ADDENDUM TO THE ARBORICULTURAL REPORT RE-EVALUATION OF TREES AT

THE TOTEM LAKE APARTMENTS SITE At NE 115th Street & 124th Avenue NE KIRKLAND, WA 98033

April 7, 2011 Addendum

To: Jon Regala, Senior Planner
From: Deb Powers, Urban Forester
Date: July 12, 2011
Subject: Urban Forester Review / ZON11-00026

ATTACHMENT 1 - SITE PLAN

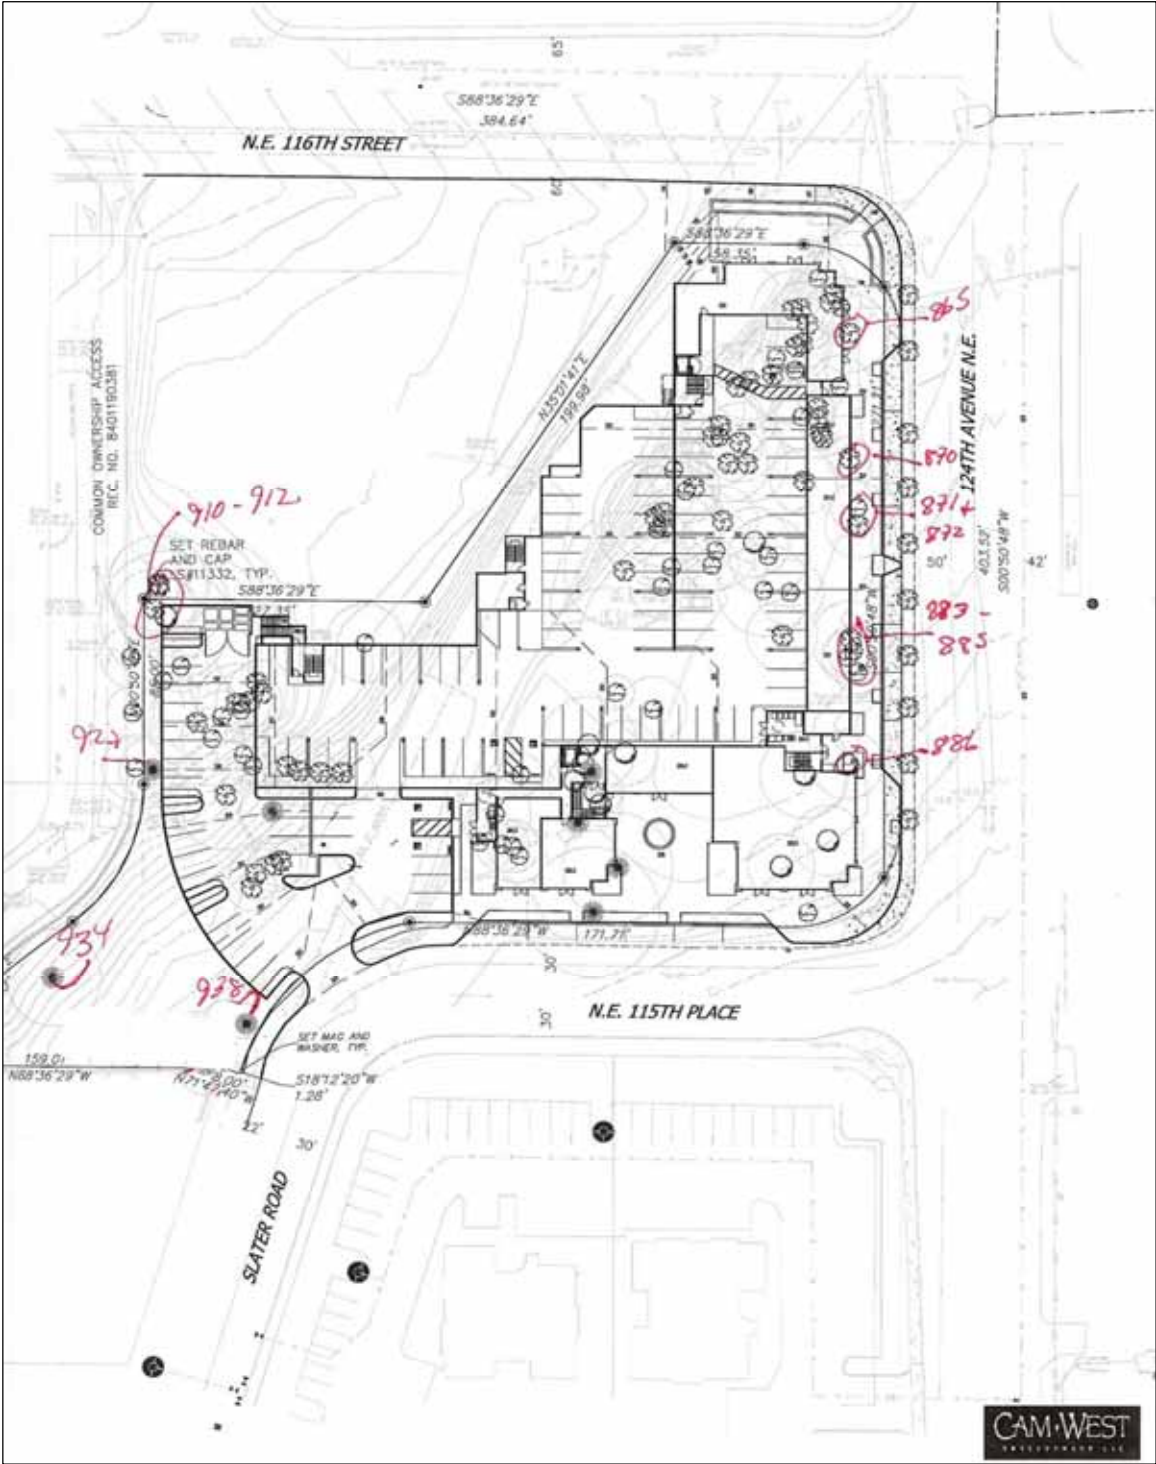
- 5) Describe the impact of necessary tree removal to the remaining trees, including those in a grove or on adjacent properties;
- There are two landscape areas where CamWest is proposing to remove trees. They are the landscape zone along 124th Avenue NE between the back of the sidewalk and the side of the building; and the landscape area along the west property line between the west property line and the western edge of the parking lot.

- Trees Along 124th Avenue NE:
 - The trees in this area include #'s 865, 870, 883, 885, and 886.
 - #'S 865, 870, 883, and 885 are Big Leaf Maples and Bitter Cherry trees that are in Poor Condition. They are *Non-Viable*.

- The tree should be removed for safety.
 - Trees Along the West Property Line
 - Trees include #'s 910, 911, 912, and 927. All four are in Fair Condition.

- However, the topography of the area will require the installation of some sort of retaining wall. These four trees will not survive long-term from the impacts of the construction of the retaining wall and parking lot.
